10/724,201

Chi-Wen Liu

Office Action Summary

DETAILED ACTION

Figure 1E

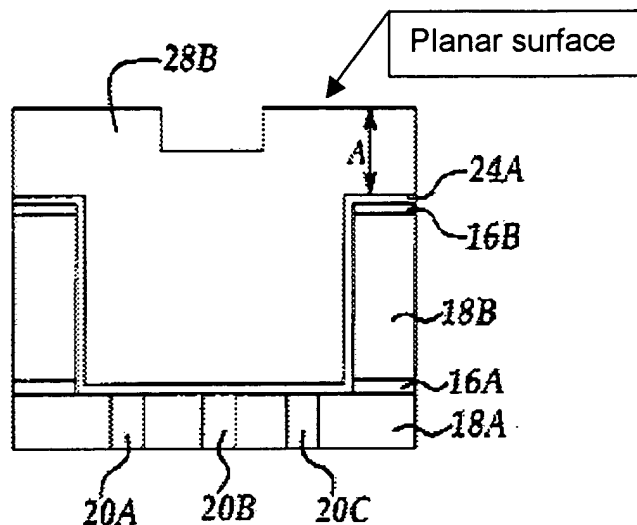
depositing a layer of material (28B, fig 1E, text [0030]) with a planar surface over the conductive layer (see figure 1E below), wherein material of the layer of material (28B) being substantially the same as a material of the conductive layer (28A); and

Applicant argues that the second copper layer 28B of Hsu is not planar. The argument is not persuasive because Hsu clearly discloses the second copper layer 28B having a planar surface (see fig. 1E above). Furthermore, Applicant does not claim that the entire upper surface of the layer of material is planar. Therefore, Hsu still meets and anticipates the claimed language of Applicant's invention.
